RE: Nine Mile Point Unit 2  
Docket No. 50-410  
NPF-69

**Subject:** *Submittal of Revision 13 to the Nine Mile Point Nuclear Station Unit 2  
Updated Safety Analysis Report and the 10 C.F.R. §50.59 Safety Evaluation  
Summary Report (TAC No. MB0304)*

FIGURE 1.2-1

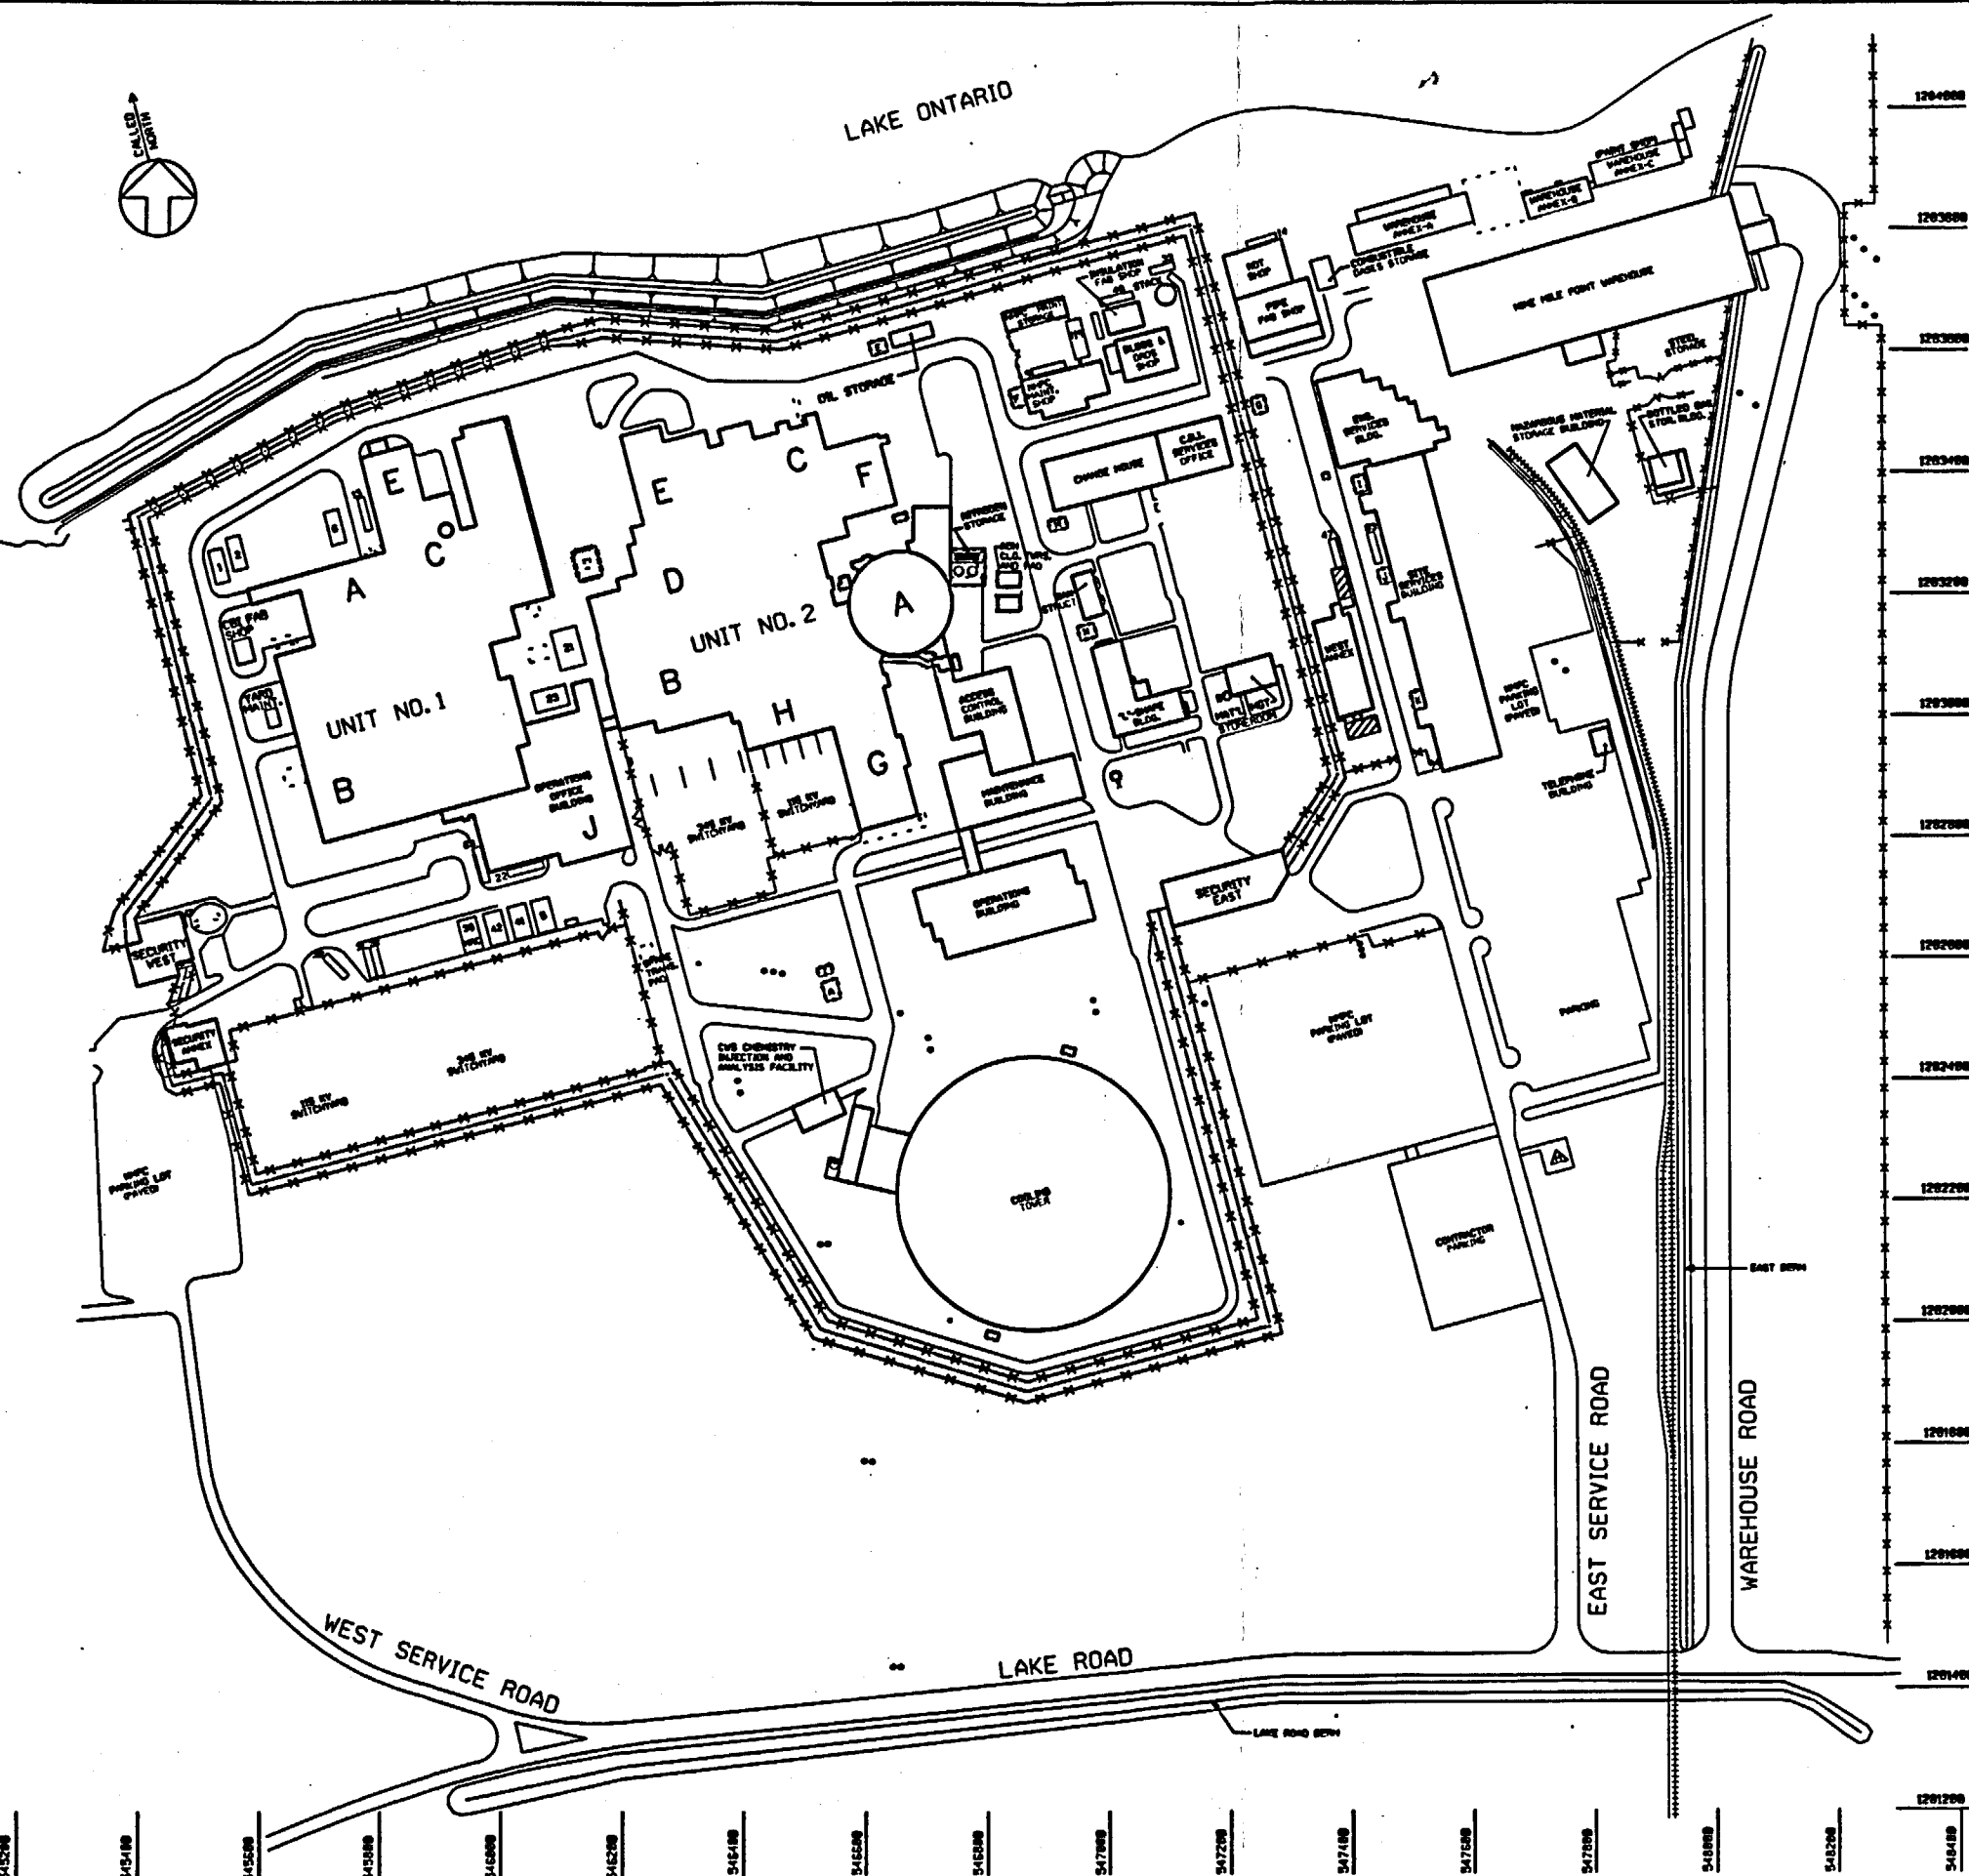
**Safety Evaluation No.:** 98-019  
**Implementation Document No.:** DDC 2S11106  
**USAR Affected Pages:** Figure 1.2-1  
**System:** N/A  
**Title of Change:** Demolition of Steel Fab Shop  
**Description of Change:**

**FIGURE 1.2-10**

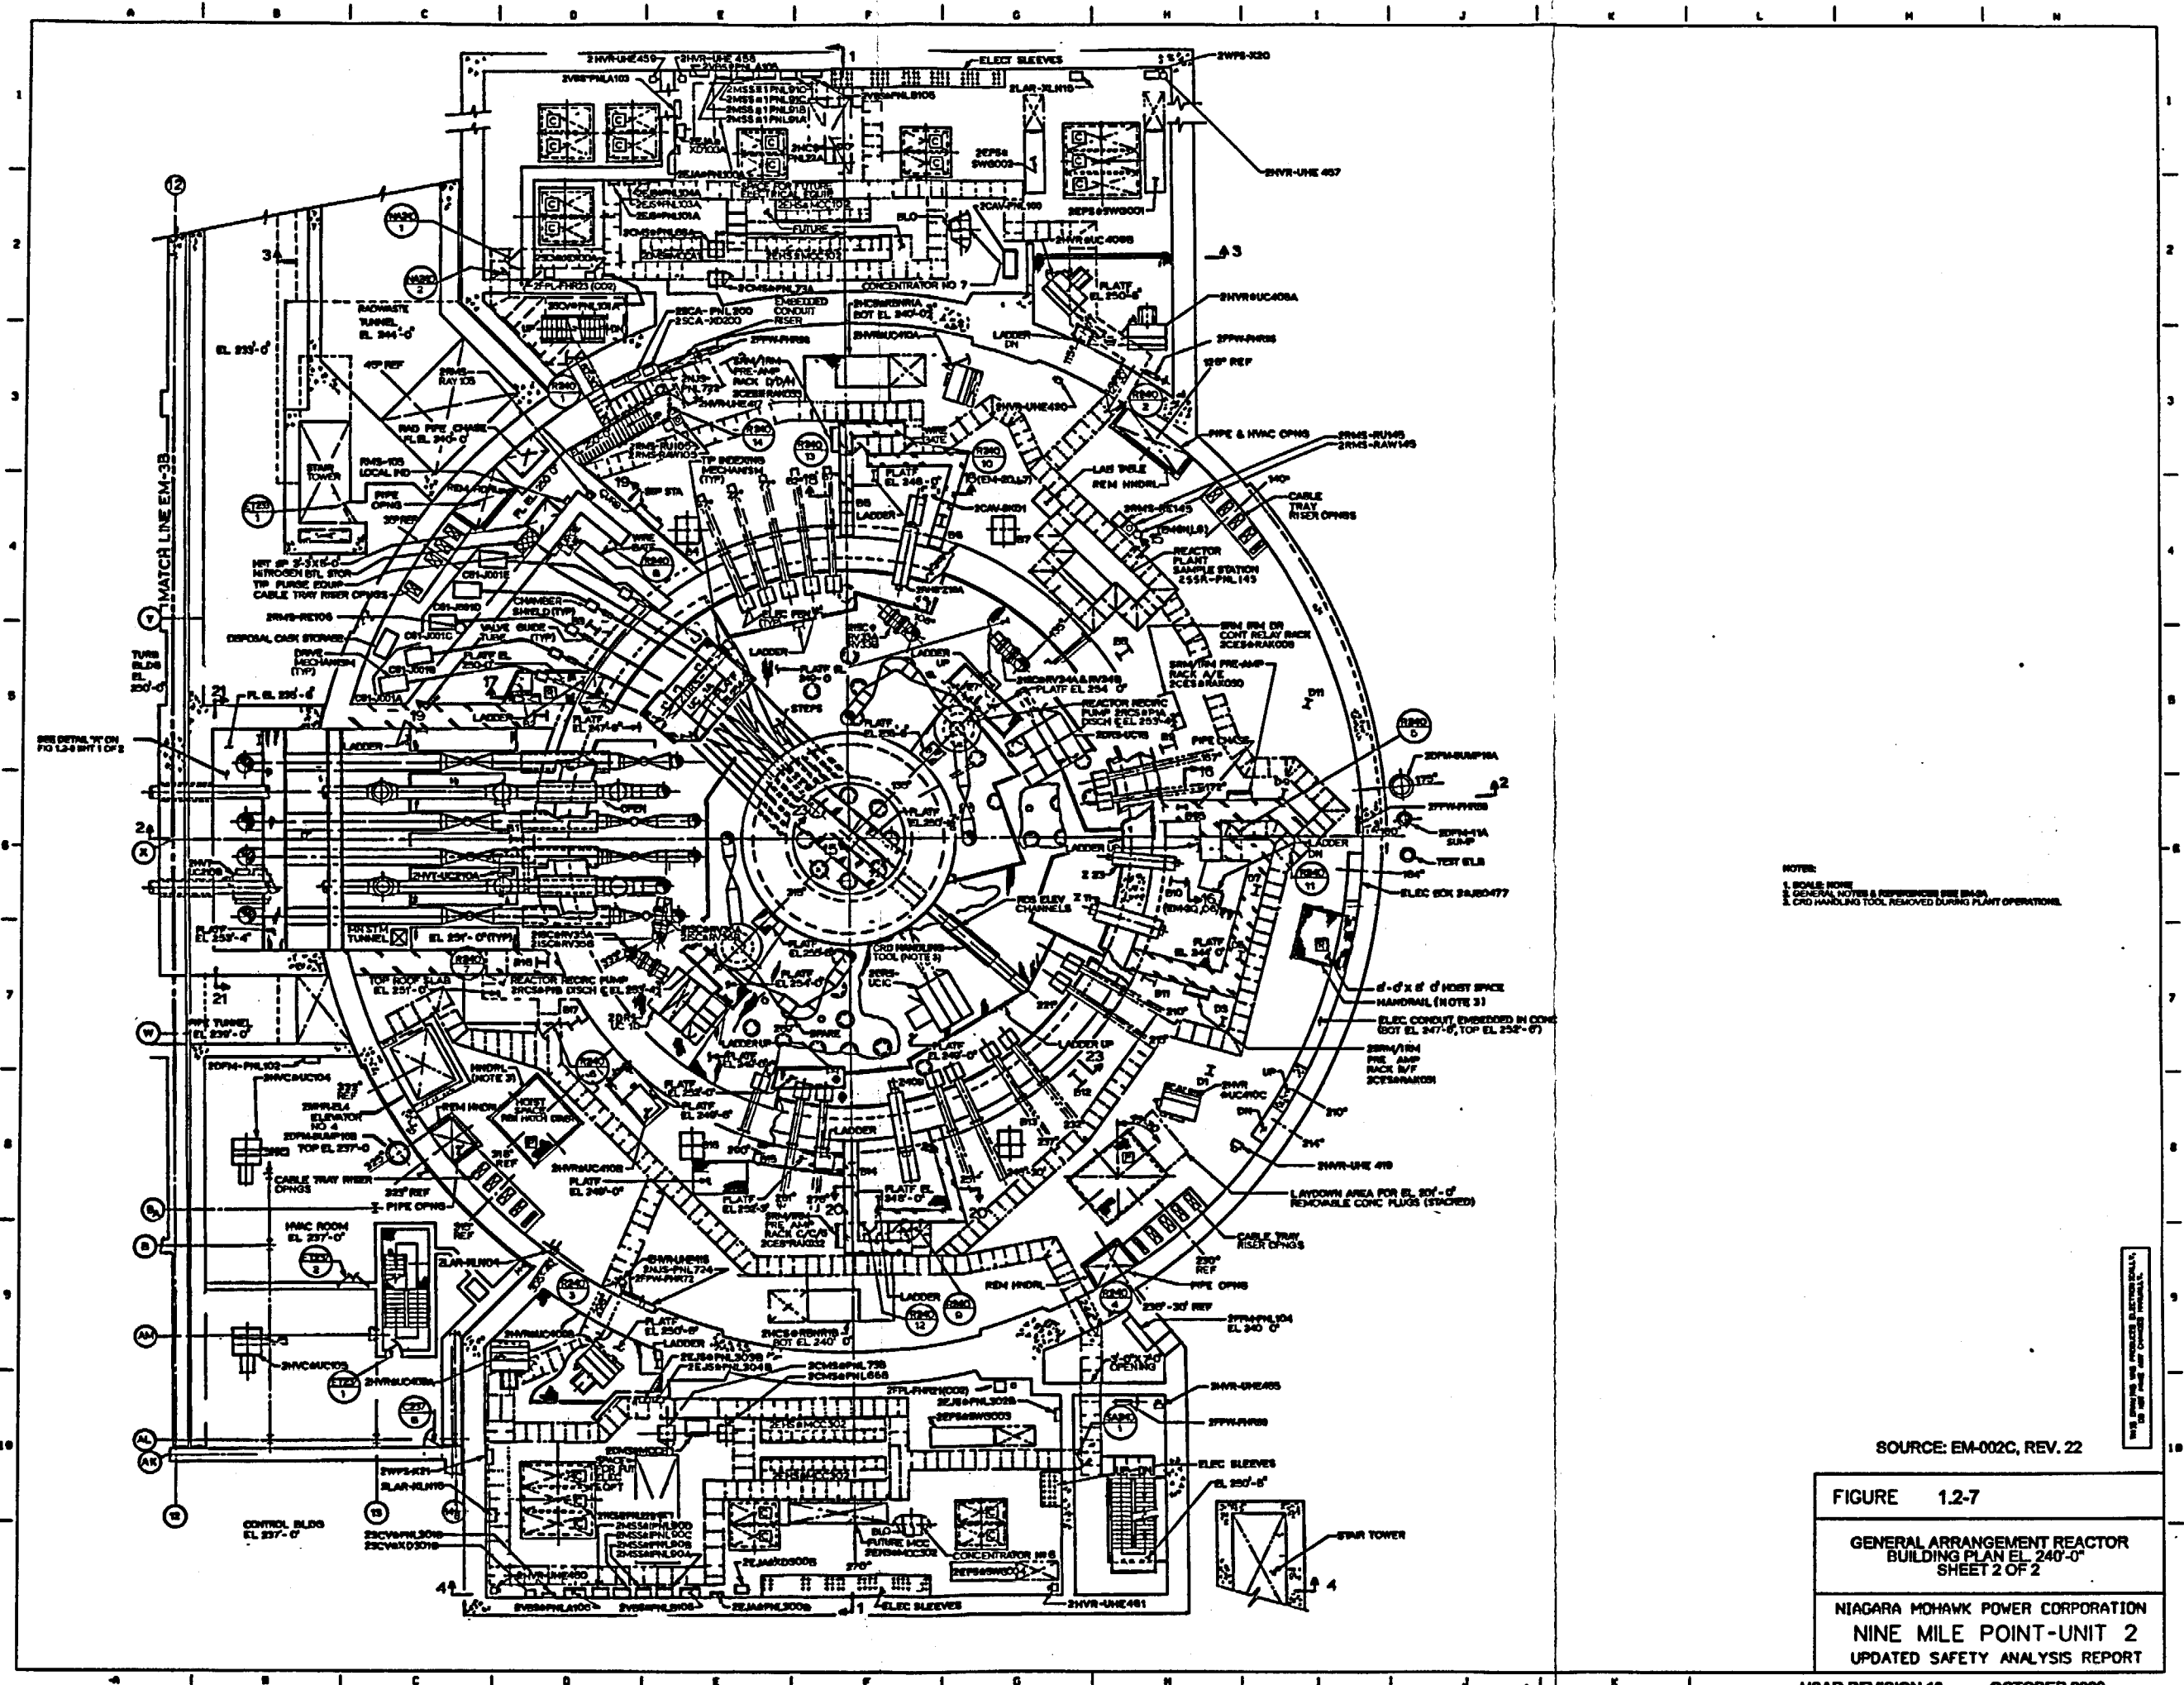
**USAR Affected Pages:** Tables 9A.3-1 Sh 9, 9B.5-1; Figure 1.2-10 Sh 1

**SOURCE: EE-27B**  
**FIGURE 1.2-15**

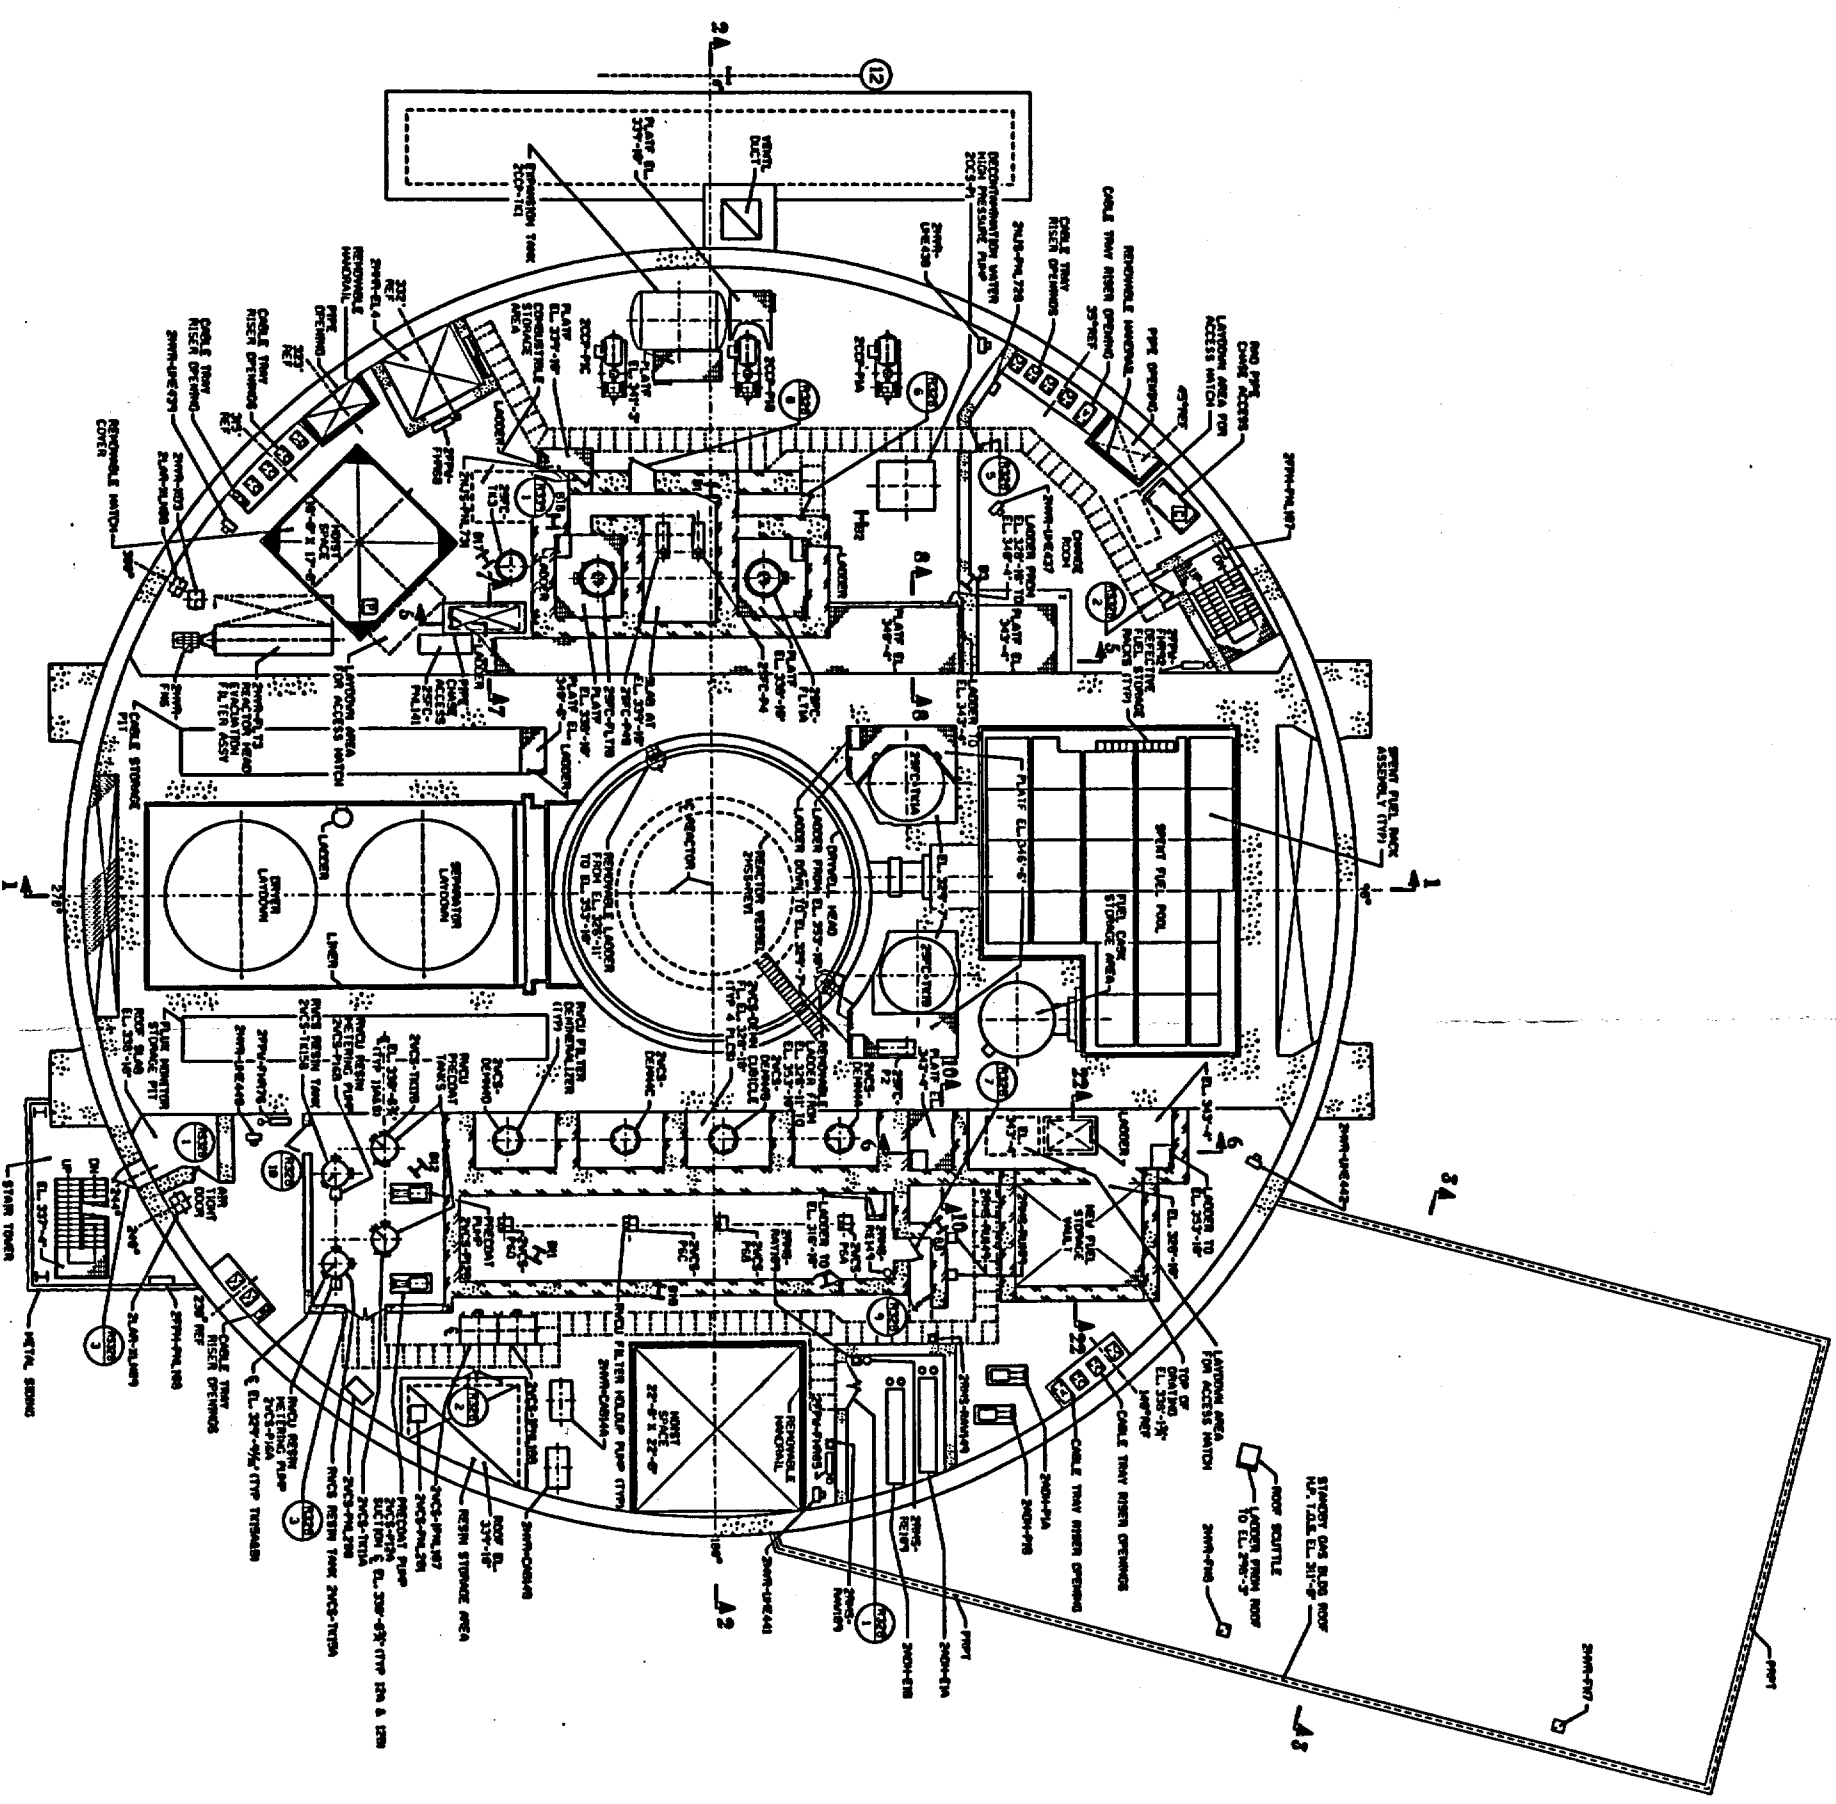
**USAR Affected Pages:** 7.7-33; Figure 1.2-15 Sh 2
